**RE: Catalonia Subdivision
Tr 1 & 2, The Trails Unit 3A
Drainage Report Stamp Date: 3/29/19
Grading Plan Stamp Date: 3/29/19
Hydrology File: C09D013**

Based on the submittal received on 3/29/19 the above-referenced Drainage Report and Grading Plan cannot be approved until the following are corrected:

DRAINAGE REPORT FOR CATALONIA AT THE TRAILS SUBDIVISION

IN 1

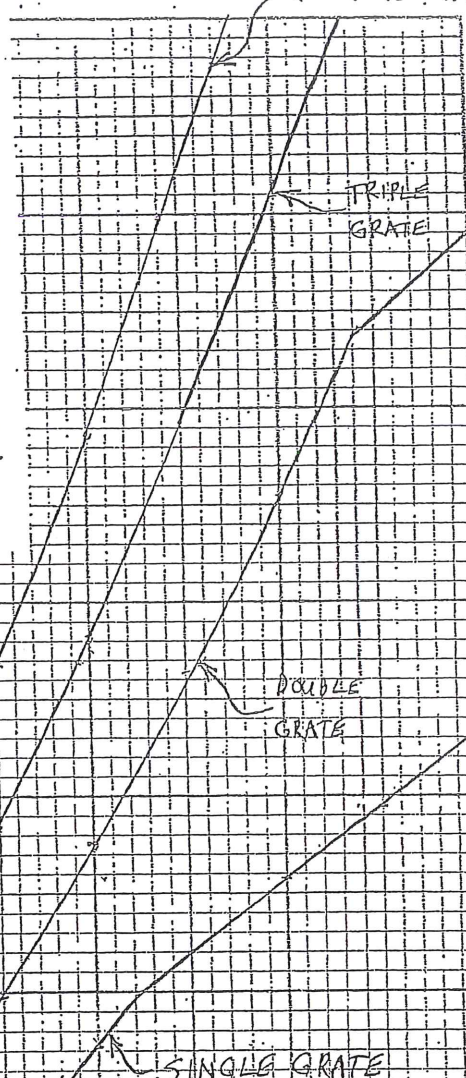
- a. Inlets in a sump need to demonstrate 2x capacity (IN1, IN2, IN3) below top of curb.

- b. The combination equation you show as eqn 1, should work, but net open area needs to be shown, and h for the orifice equation needs to be defined as height of water above the center of the opening.

- c. Grate void space (or net open area) needs to be 3.72SF, for the bike-friendly Albuquerque grate, see new Dwg 2220 (attached)
 - d. IN1 is described as one double-A, but 2 separate inlets are shown on the grading plan.

IN2-IN3

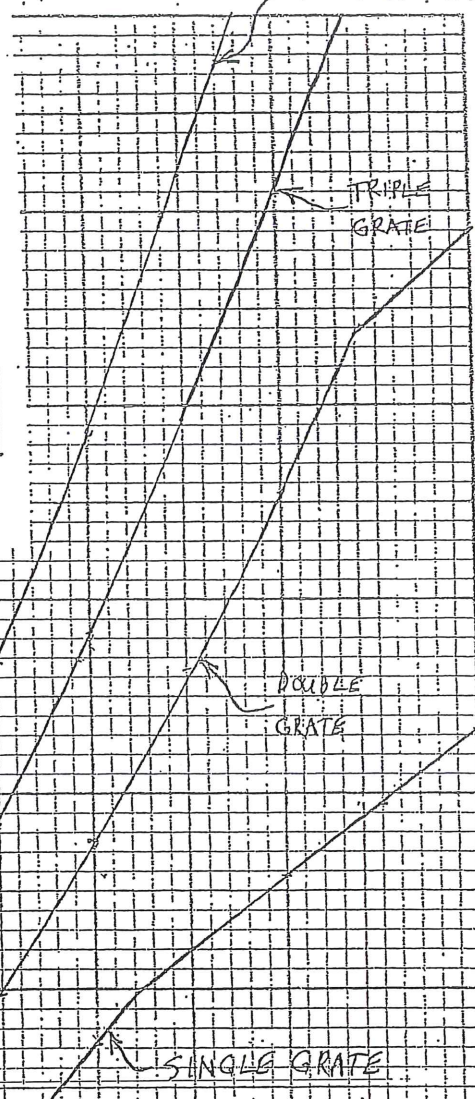
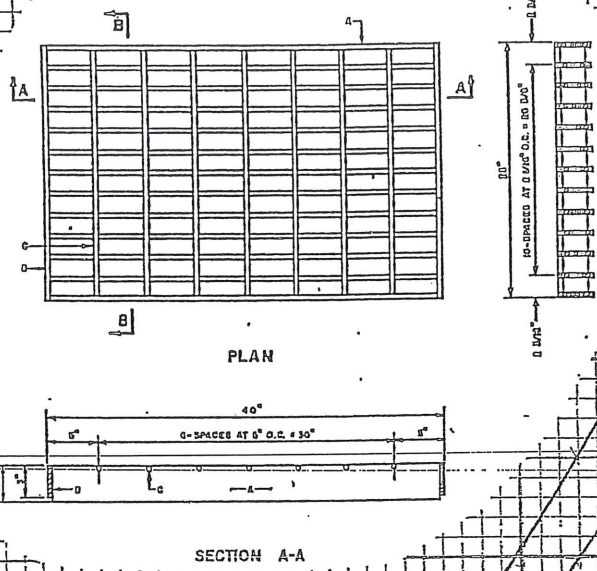
- d. Provide grate (or LP) elevation at IN2 and IN3. Ensure that there is an adequate sump between these inlets and the waterblock for Woodmont & Girona, so high flows don't simply spill over to Woodmont. This high point elevation also needs to be called out.

Profile Report
Engineering Profile - Profile - 1 (20190248.stsw)

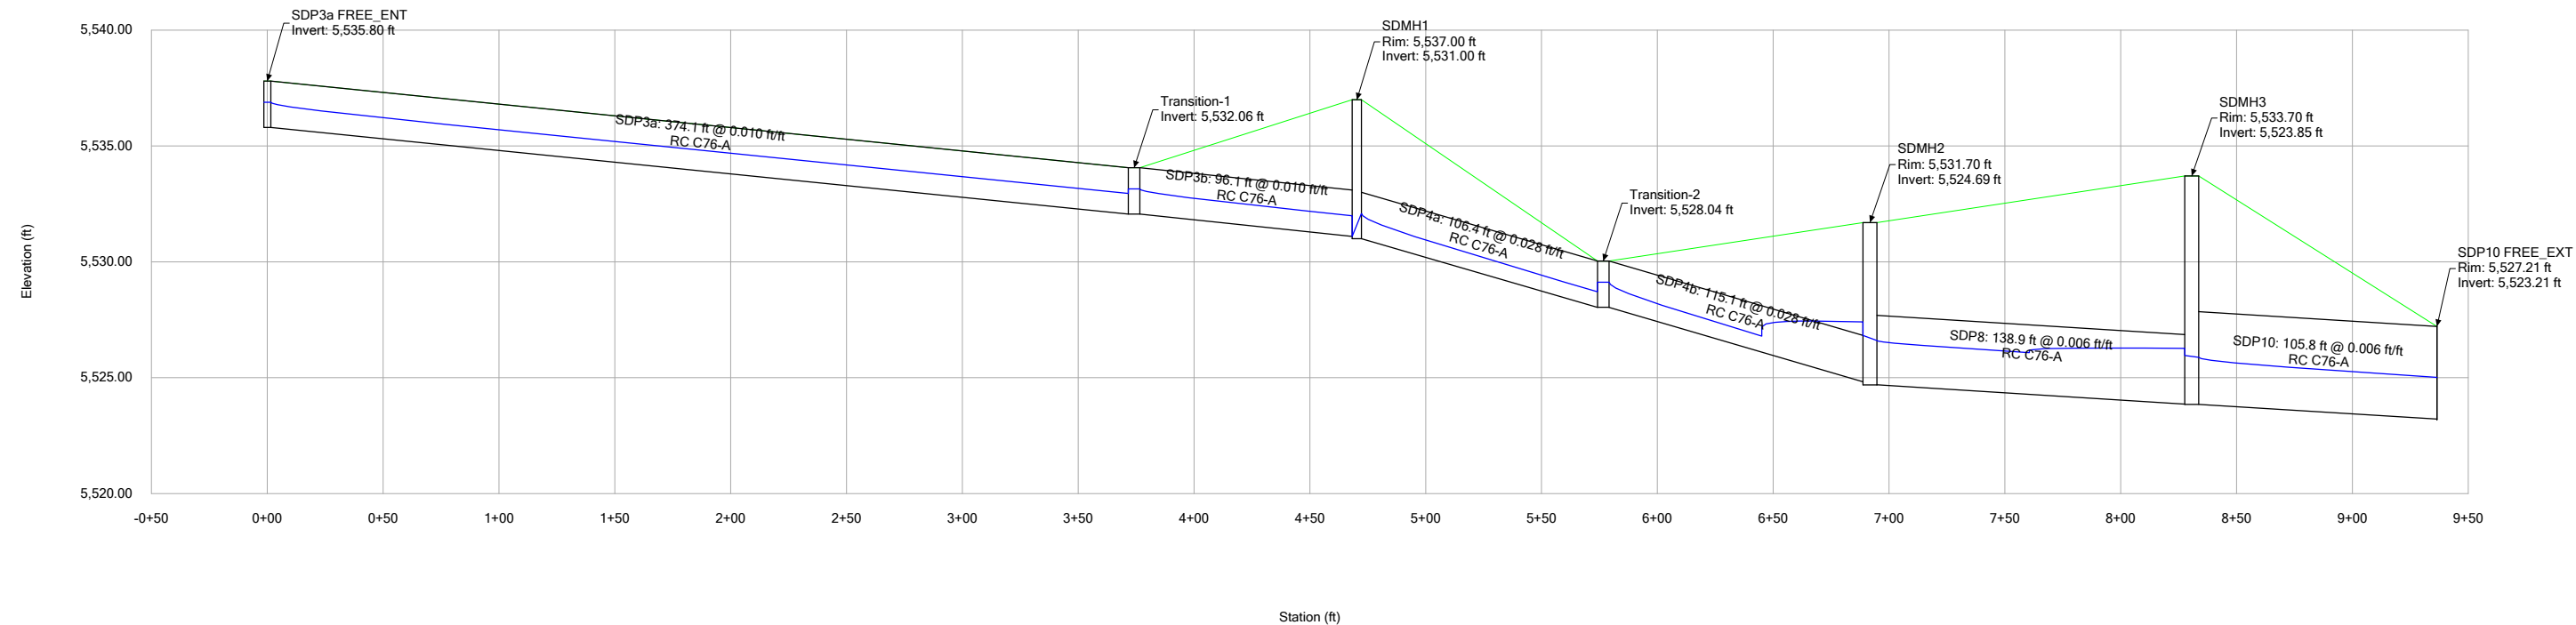
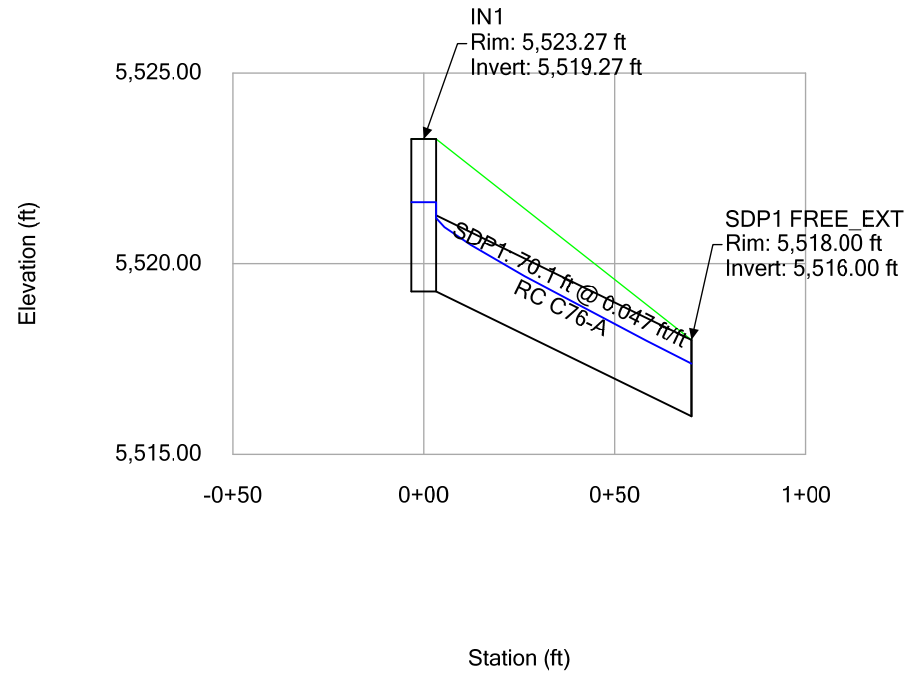
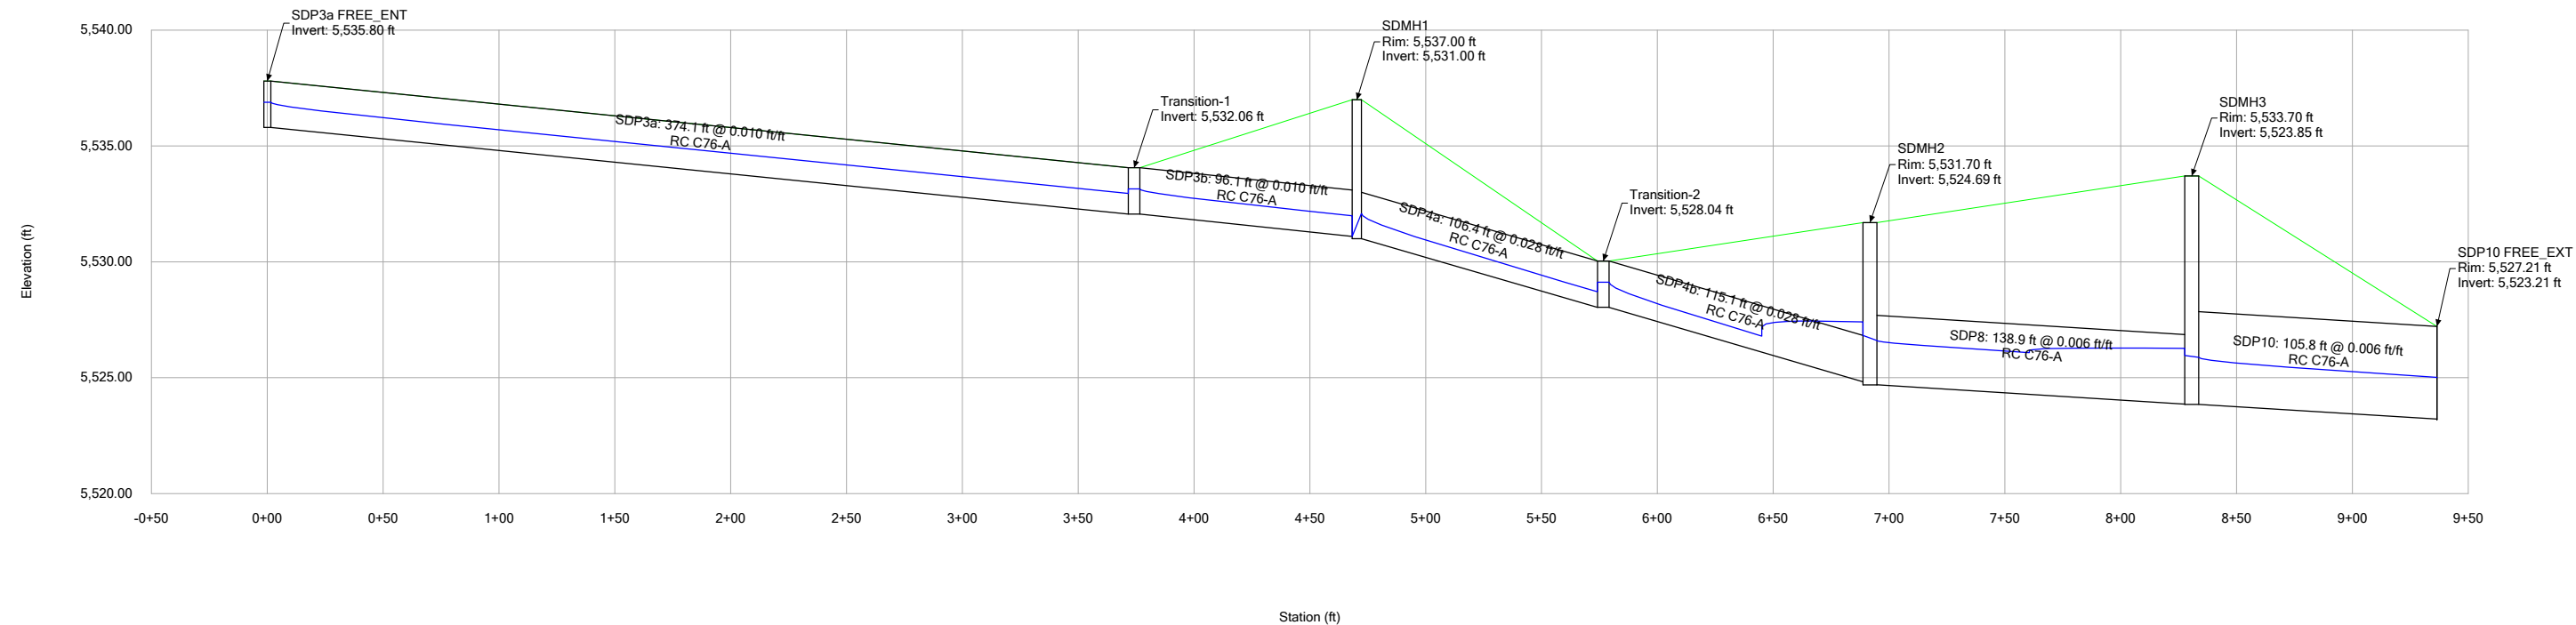
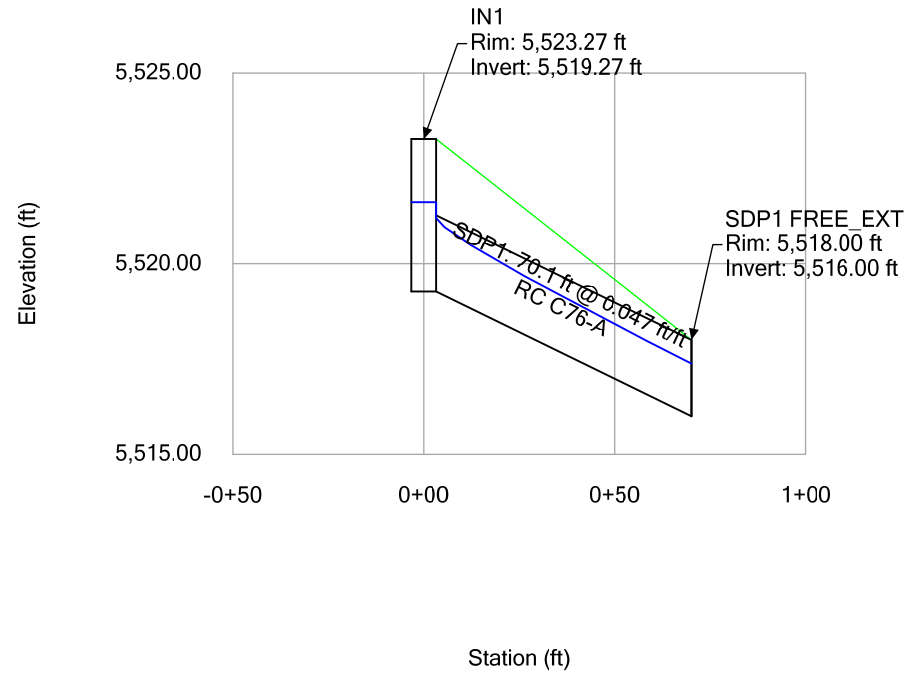
7. Storm Drain Profiles. Appendix C/F.
 - a. Appendix C and Appendix F look to be the same thing.
 - b. Provide a column(s) on the table showing EGL.
 - c. Use the 10-yr water surface elevation (WSE) in the receiving pond as the beginning WSE for the HGL calculations, or the actual WSE, per the pond routing tables (to be prepared).

- d. Transition 1 and Transition 2 will not be allowed; provide manholes at these locations.
 - e. Curvilinear pipe and bends are allowed in select cases; please see attached draft guidance for the new DPM.

- f. HGL profiles are missing for SDP9 and SDP2.

CATALONIA
OVERALL GRADING PLAN

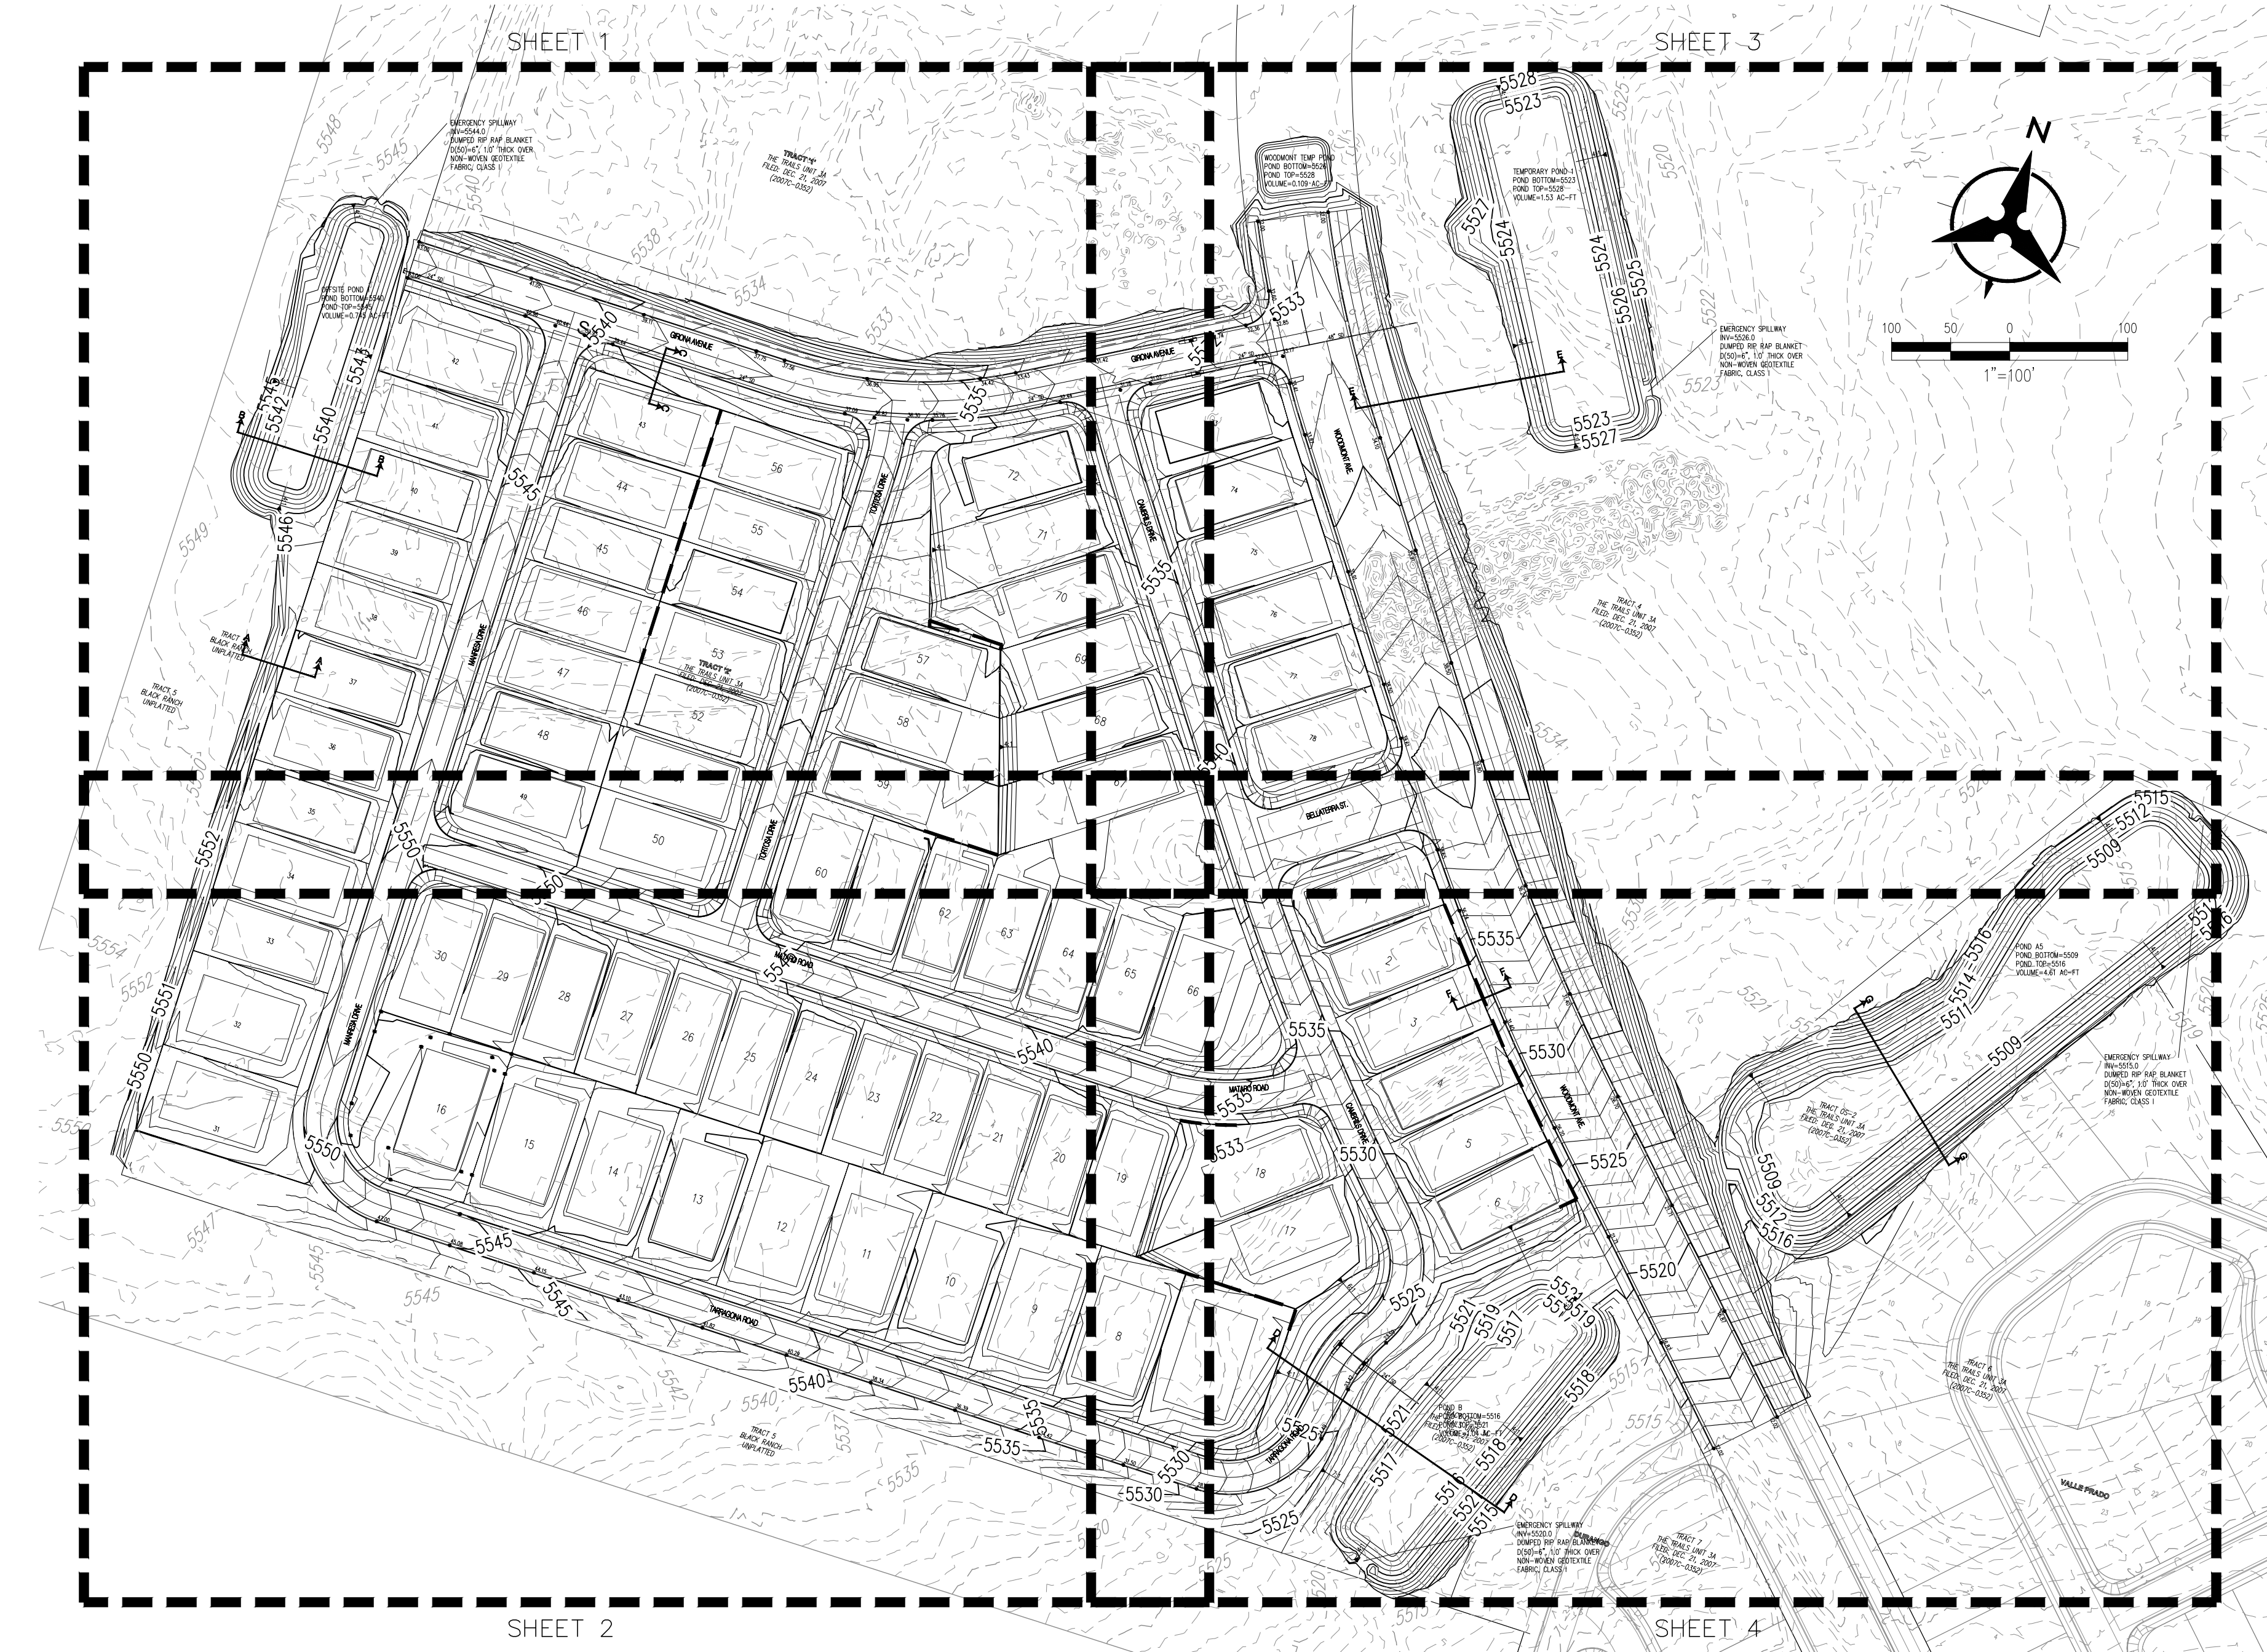
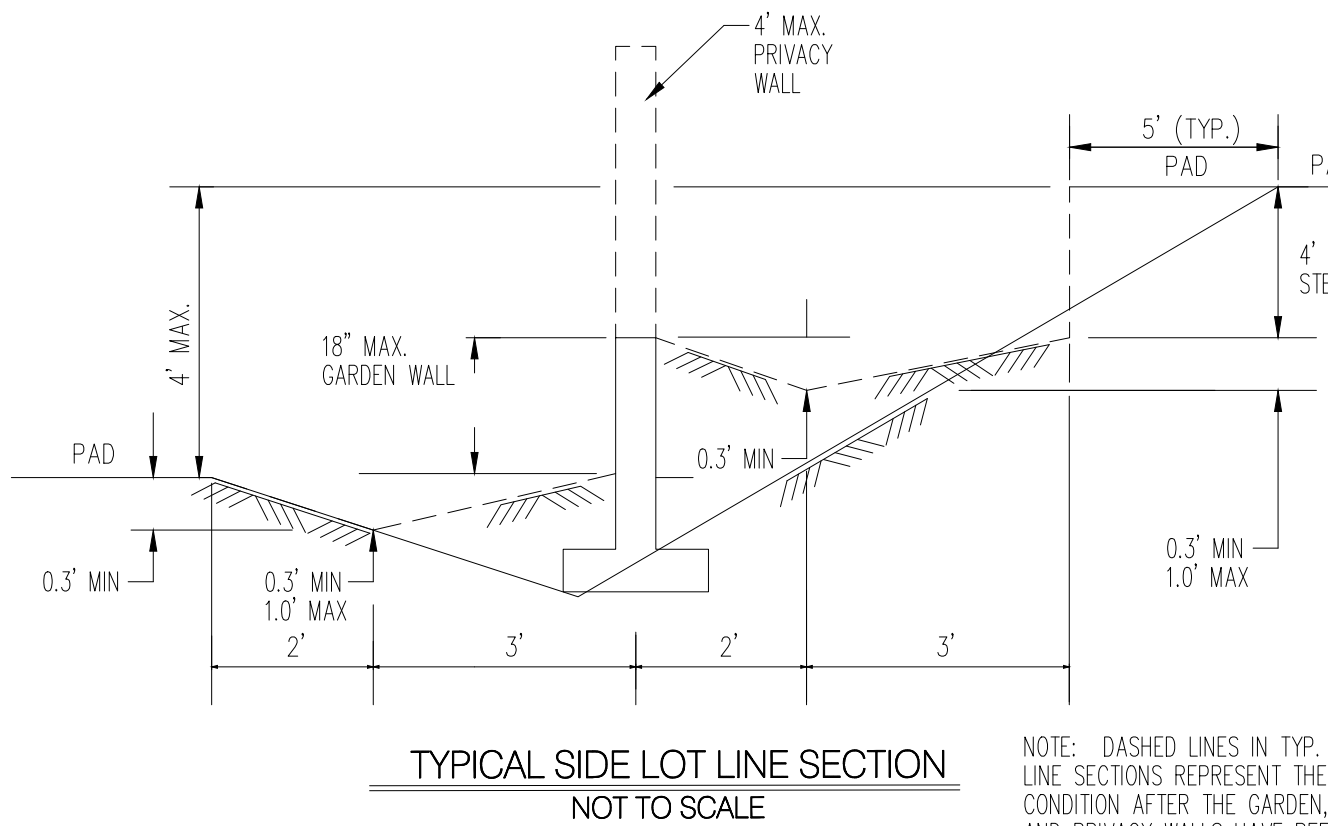
10. Grading Plan Remarks.
 - a. Sheet labeling shown on Sheet 1 is incorrect.
 - b. Do not grade on Lot 9-16, Valle Prado Unit 5.
 - c. Add a line type to the legend for *Retaining Wall, Constructed Prior to Grading/Pad Certification*. These are for the side lot retaining walls to be built by the grading contractor.
